USNRDL-TR-582  
17 September 1962

DESIGN MODIFICATIONS AND 1962 COST ANALYSIS  
FOR A STANDARDIZED SERIES OF FALLOUT SHEILDERS

by  
Lewis G. Porteous

prepared for the  
OFFICE OF CIVIL DEFENSE  
DEPARTMENT OF DEFENSE

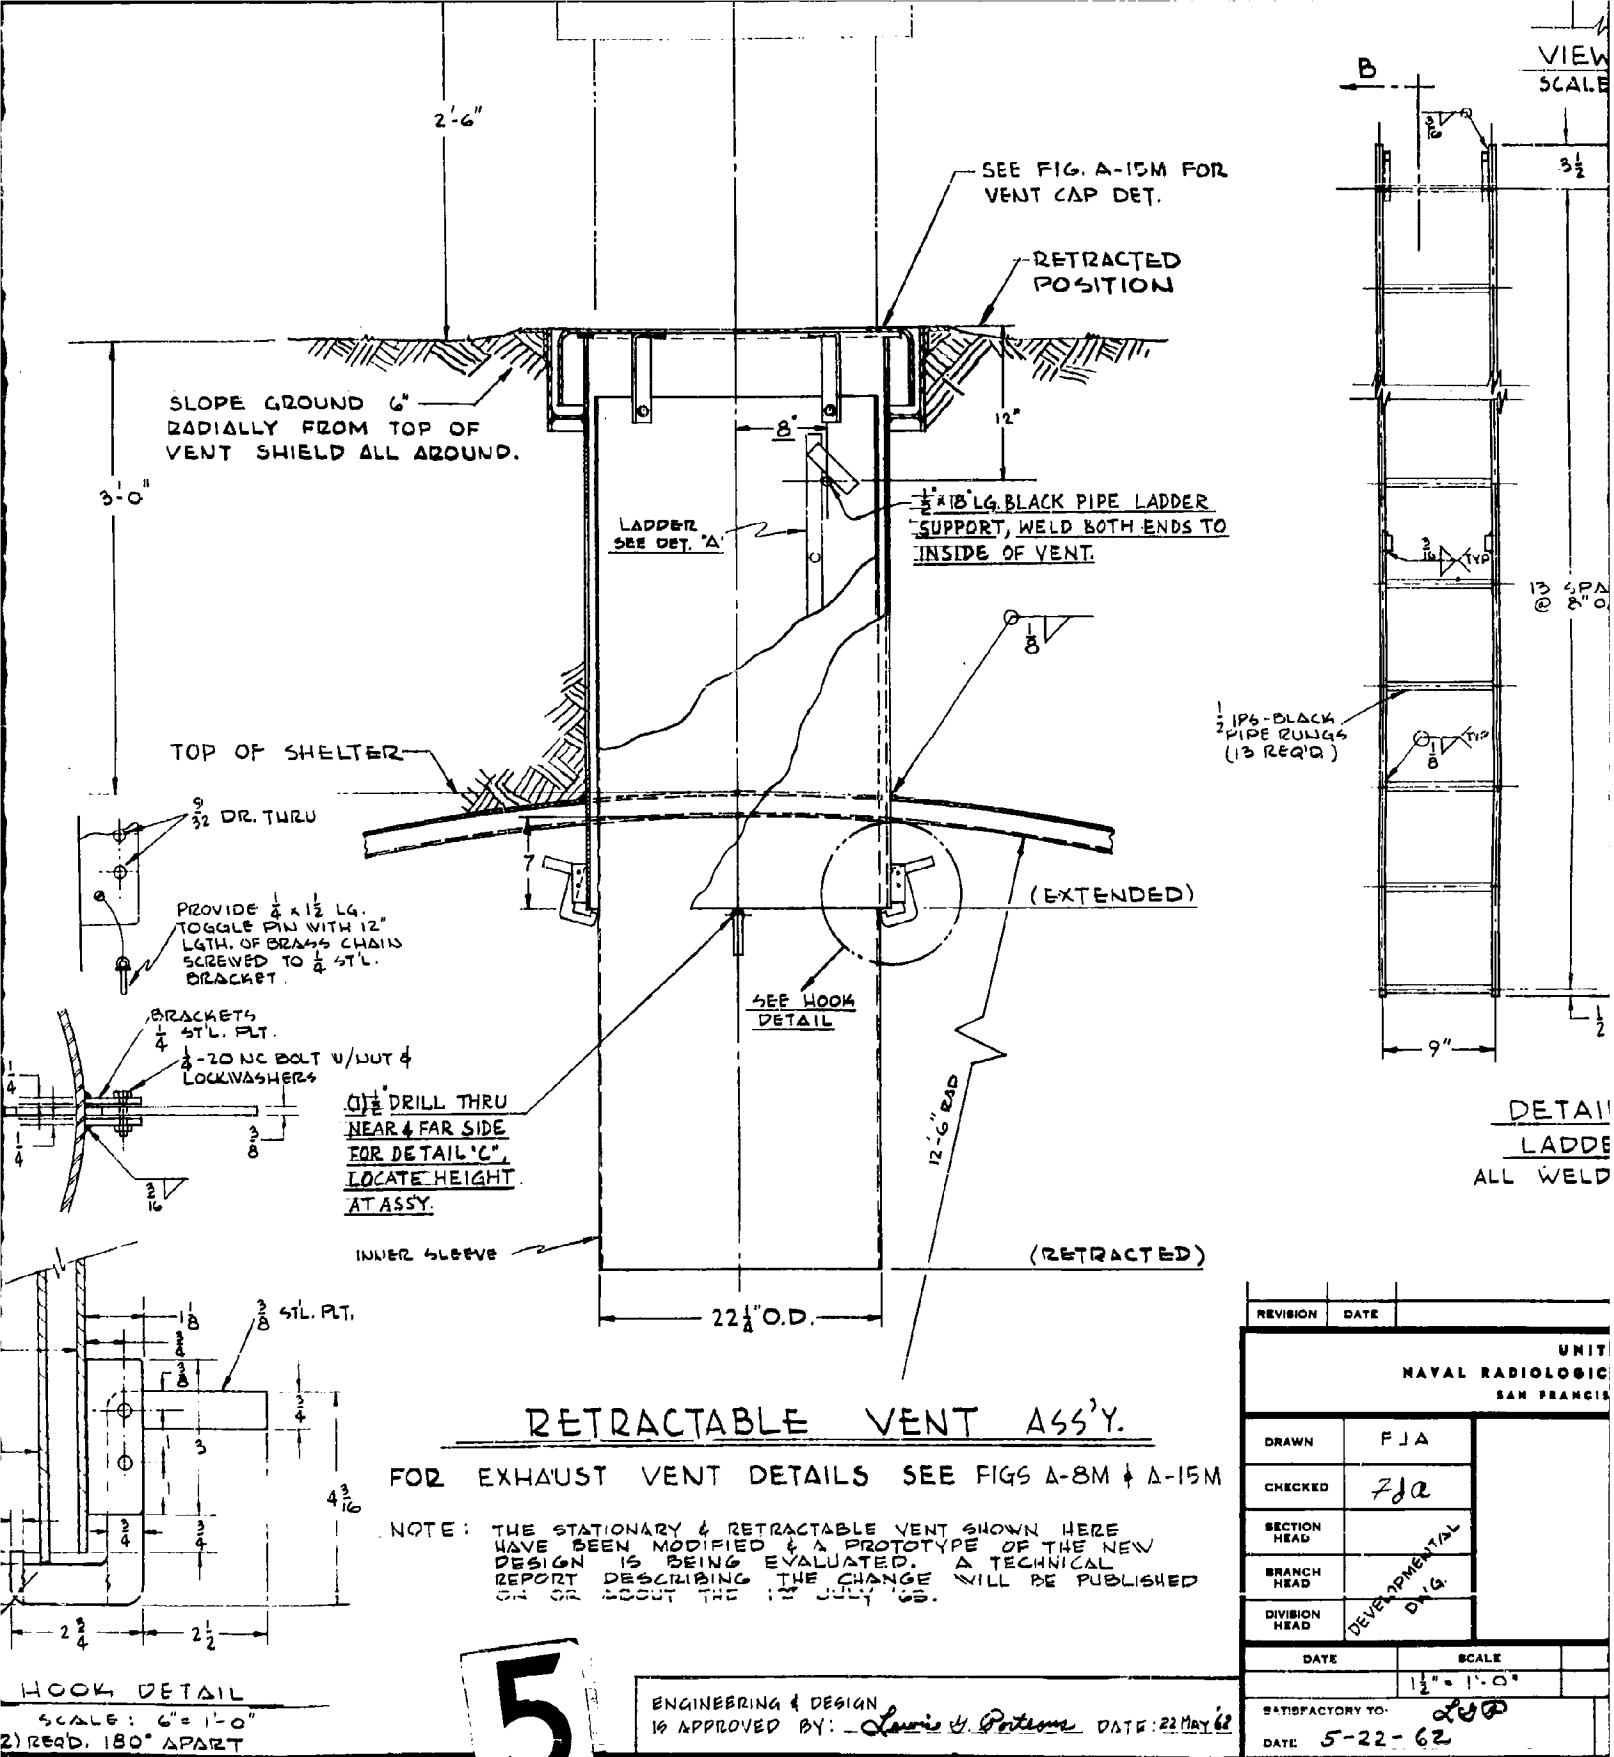
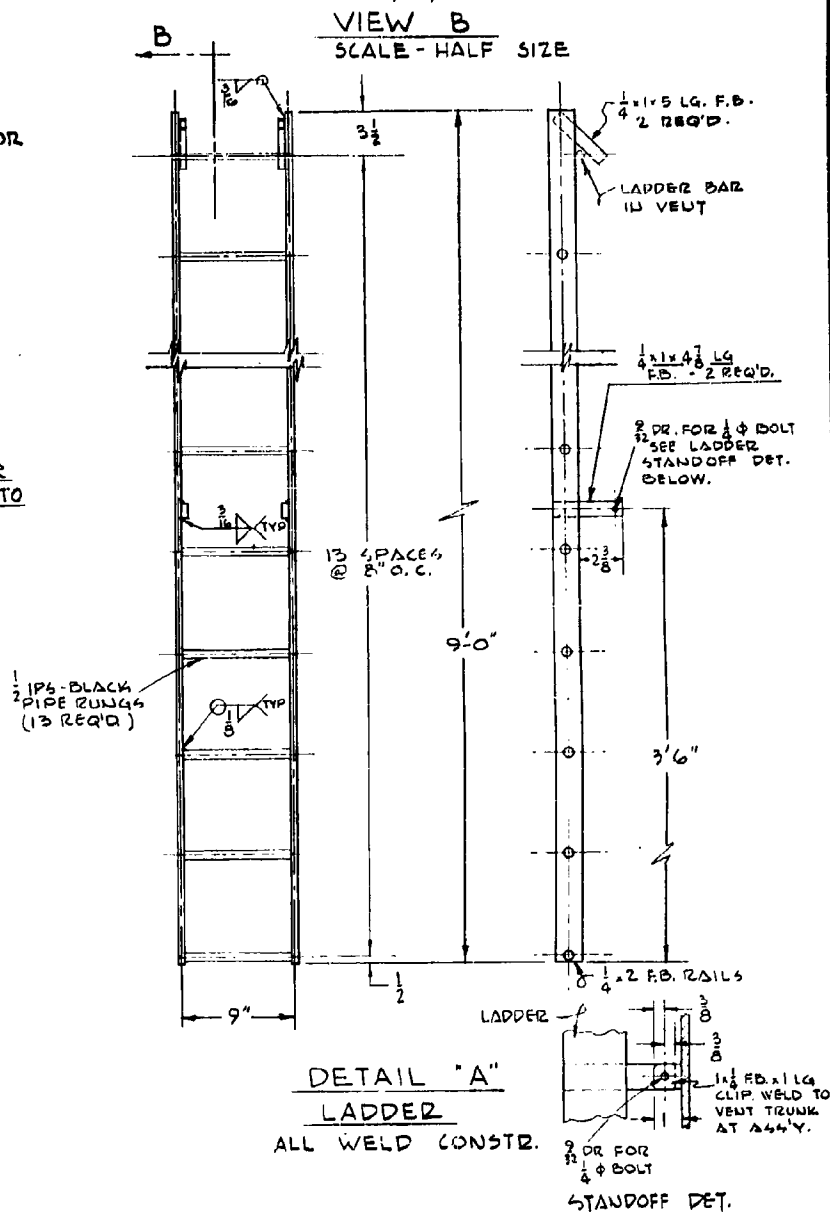
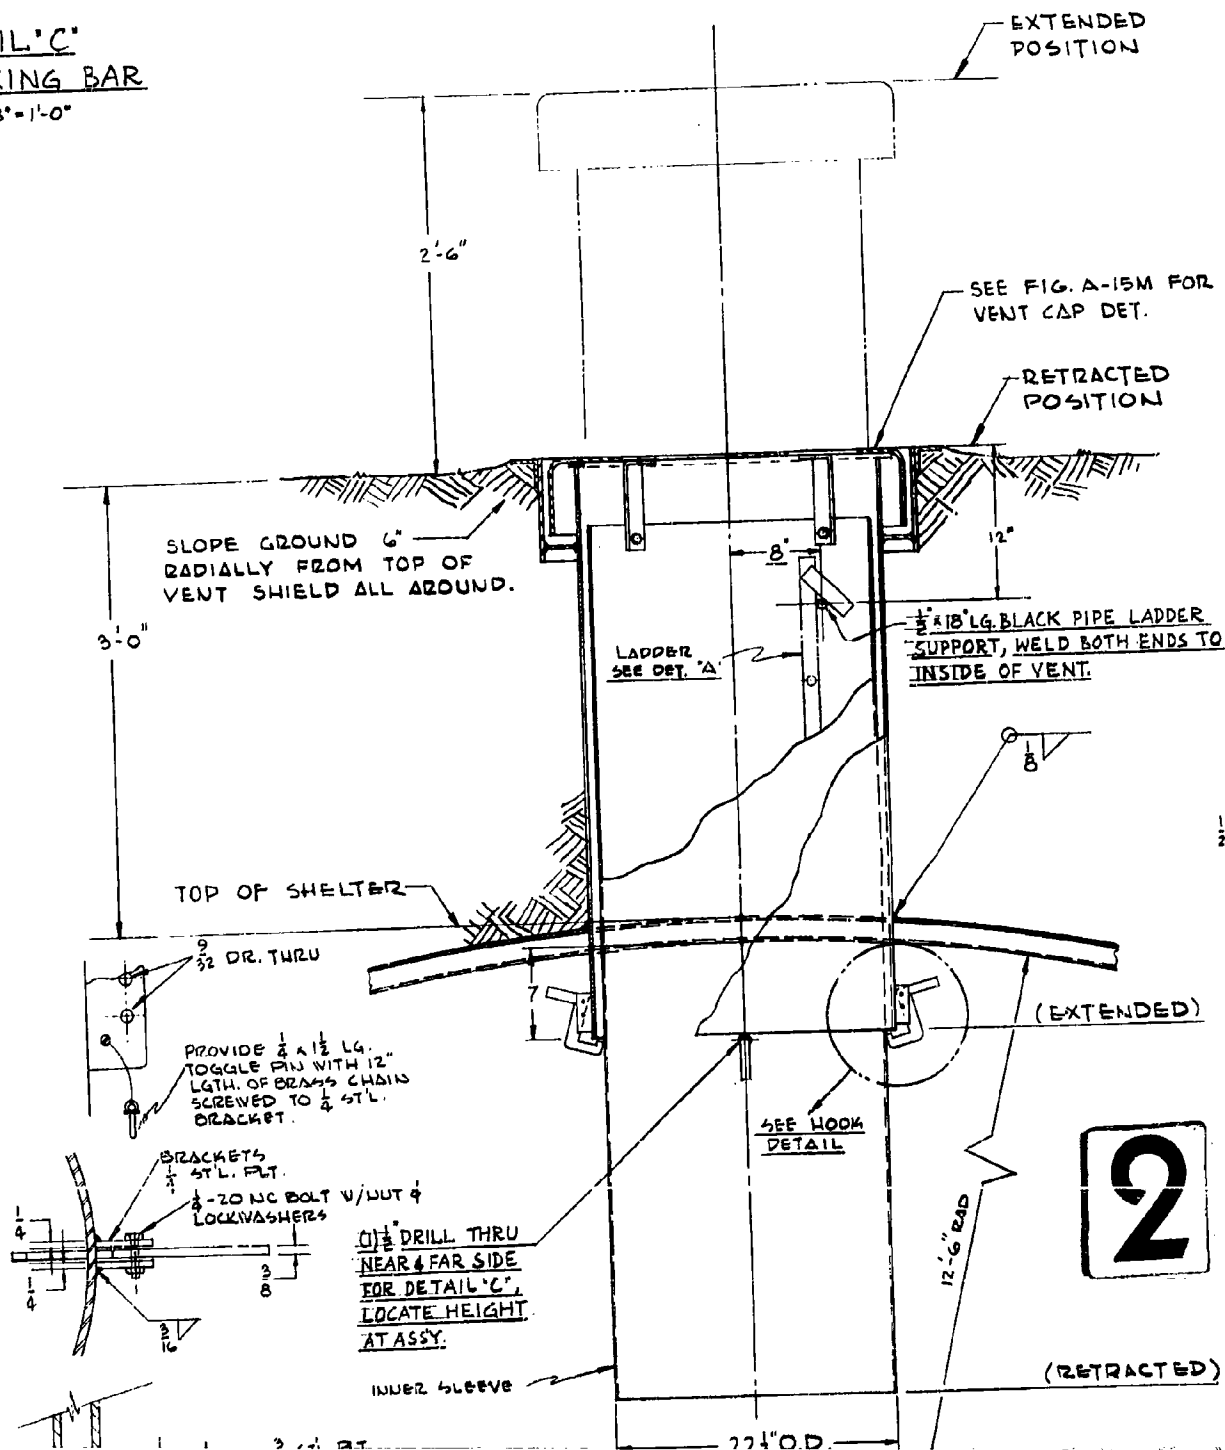
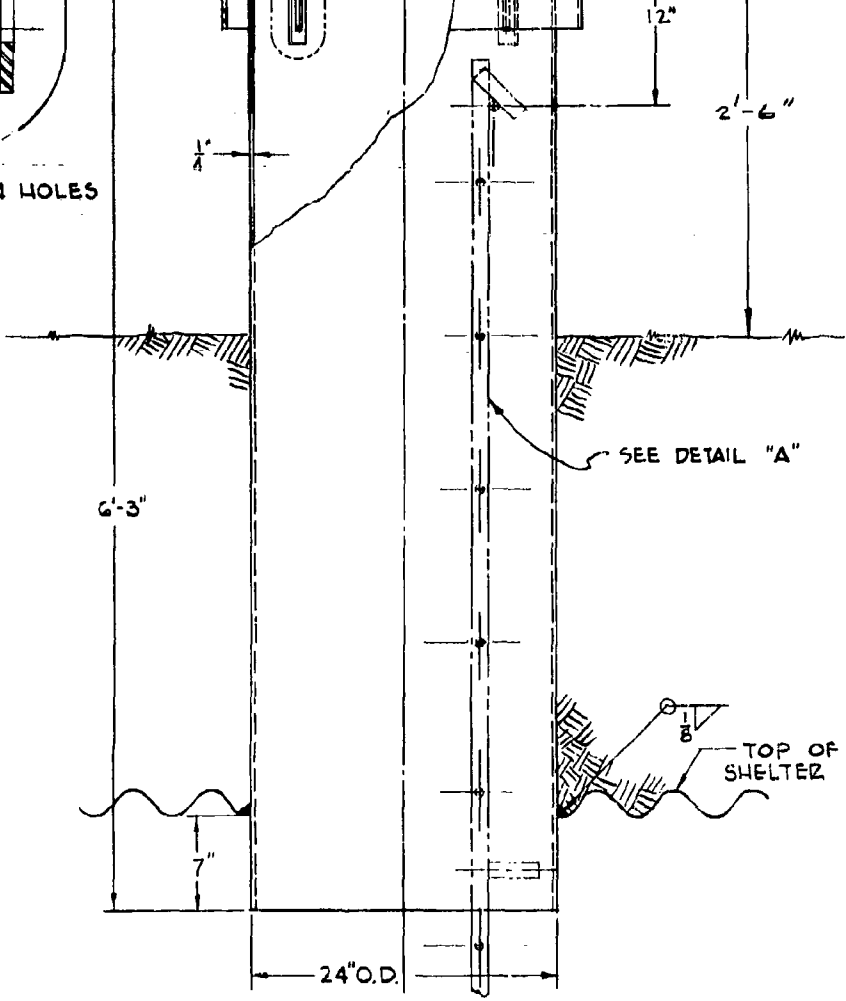
Minor modifications have been made in the exhaust vent design to reduce costs. Refer to Figs. A-7M and A-8M for details.

The design of these systems has been modified to decrease the possibility of the water and fuel piping connections breaking at their point of entry to the shelter during the positive blast pulse. See Fig. A-7M.

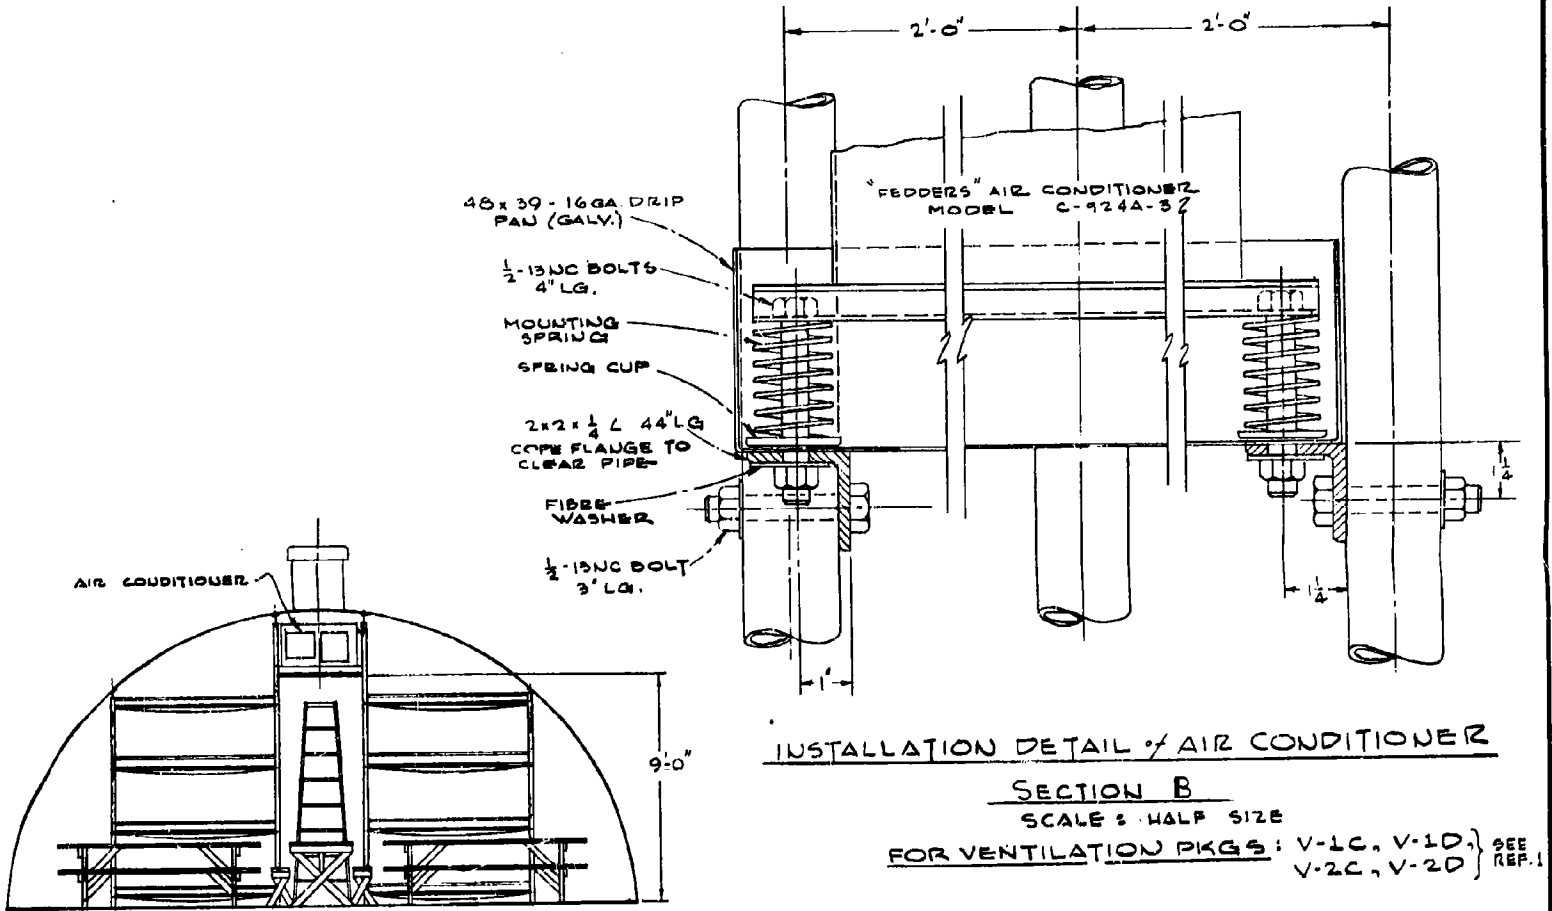
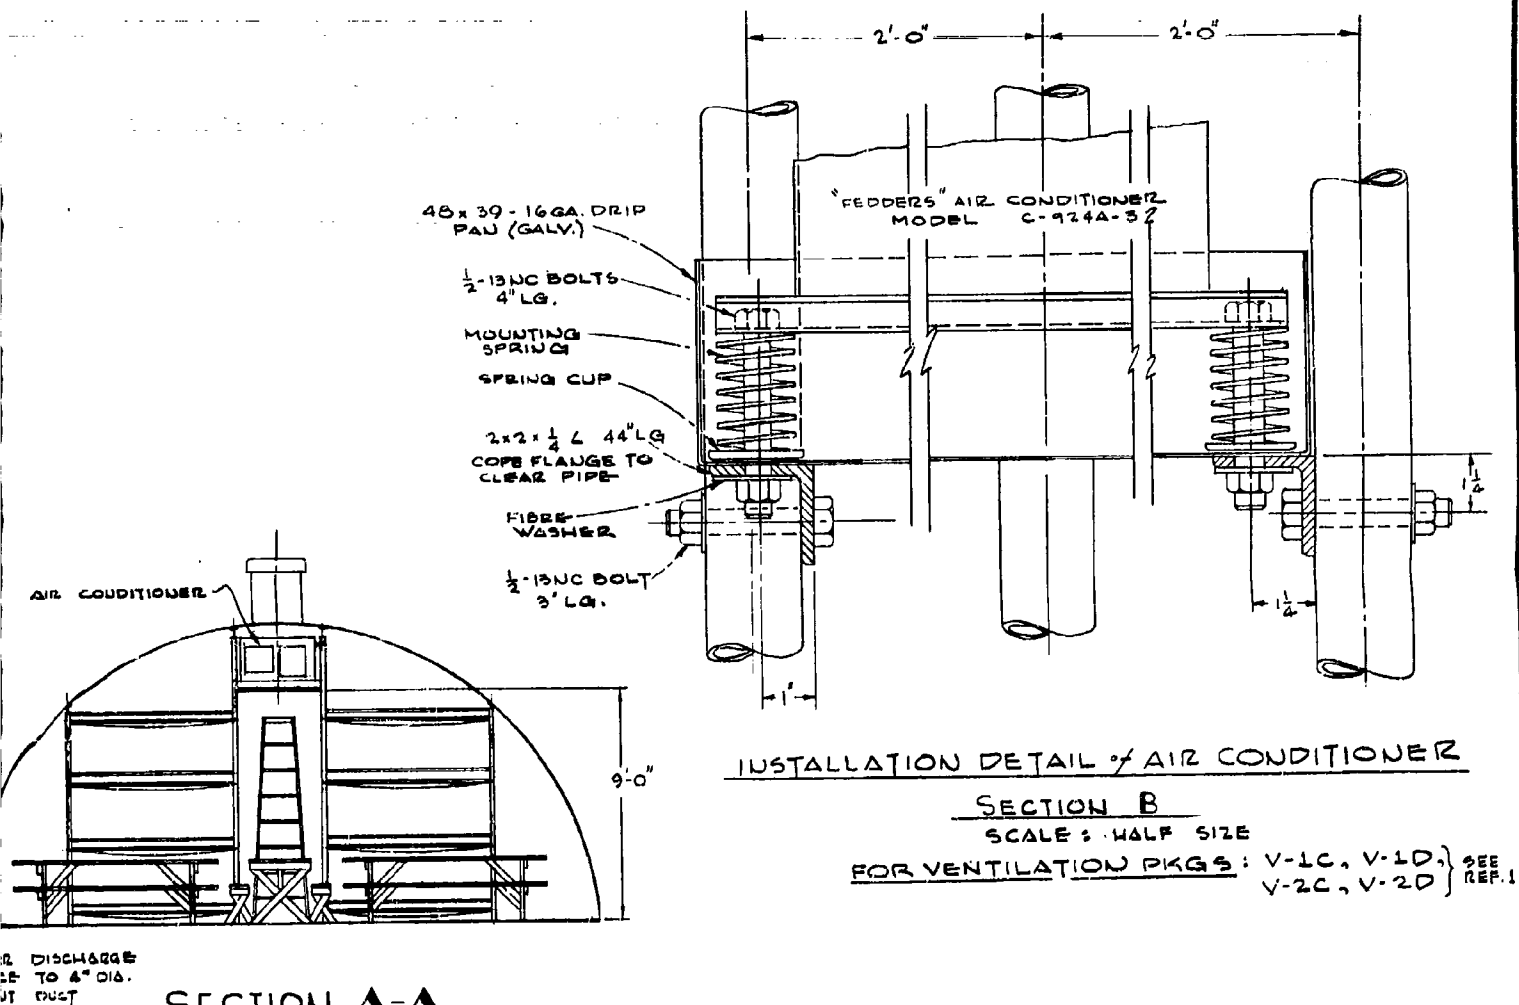
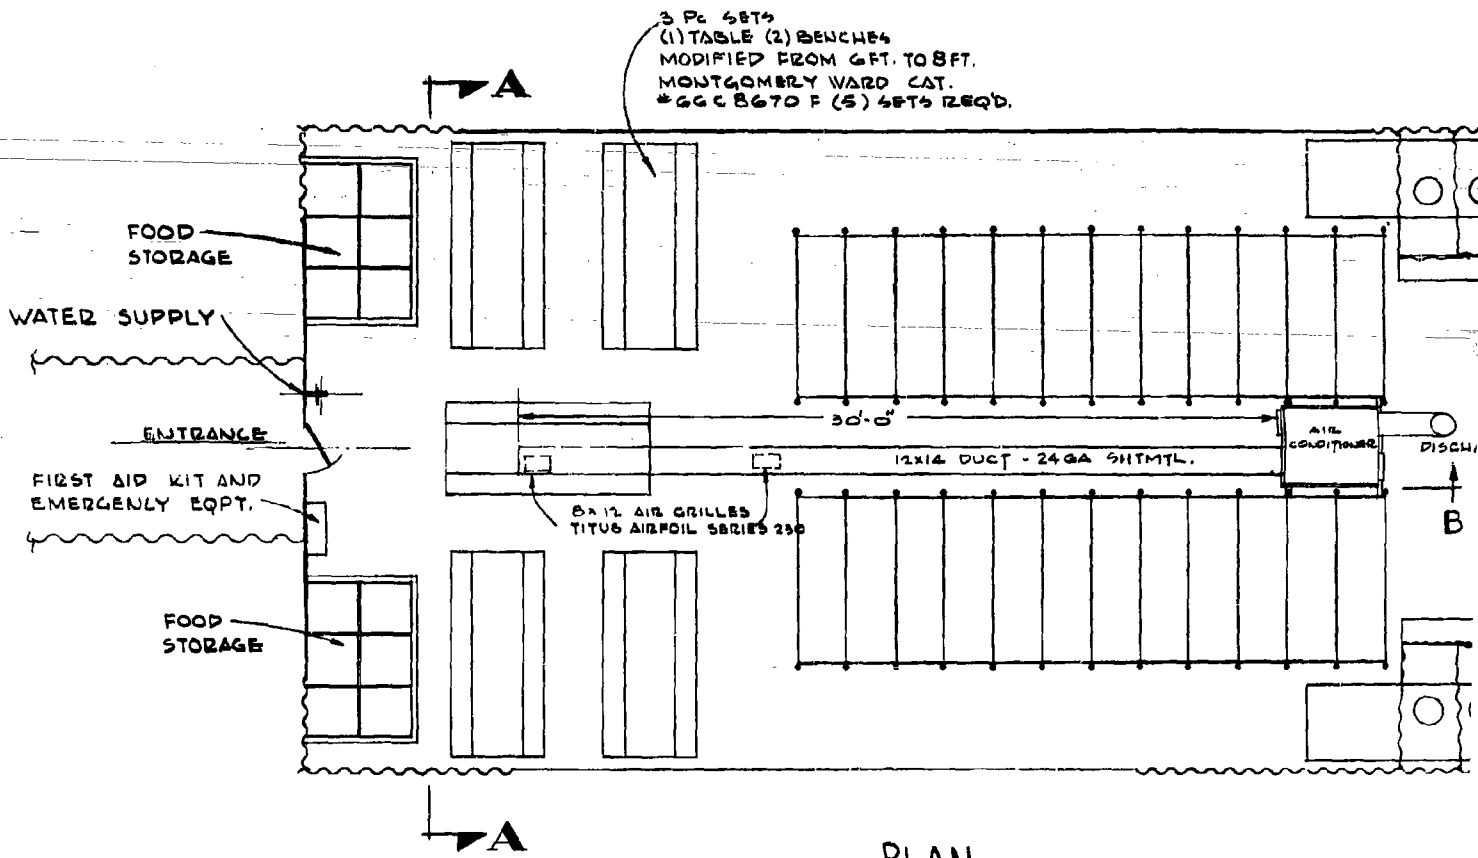
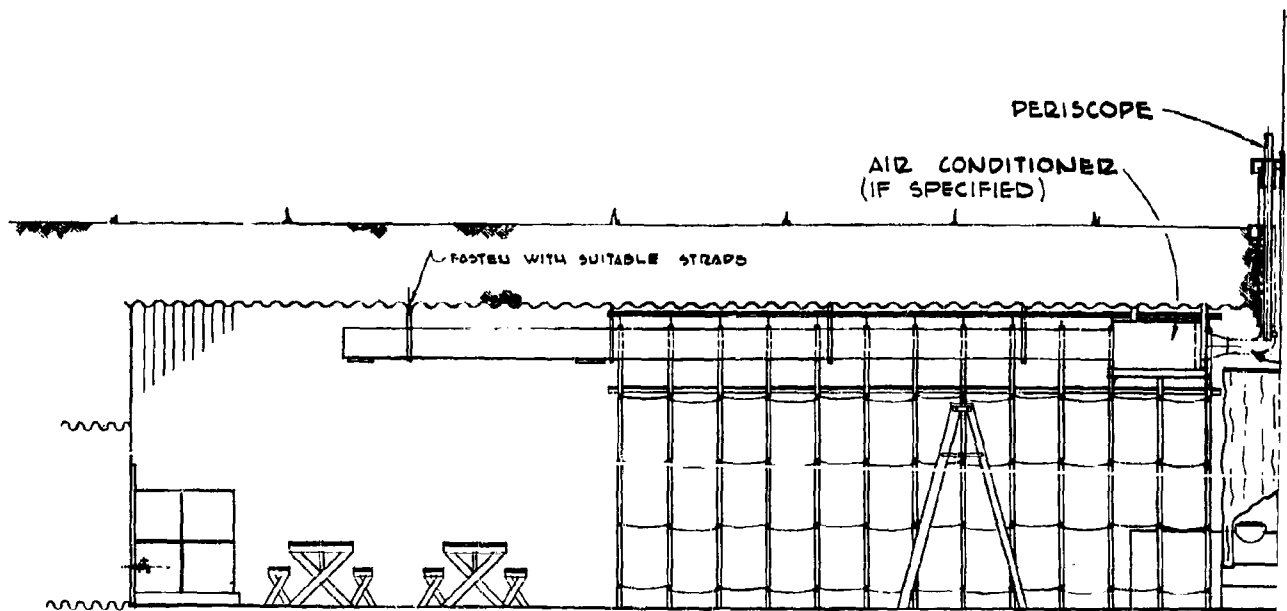
The design of the wooden tables and chairs that were specified to be used in Ref. 1 has been modified to reduce cost without affecting the 14-day usability period required of this furniture. See Fig. A-9M.
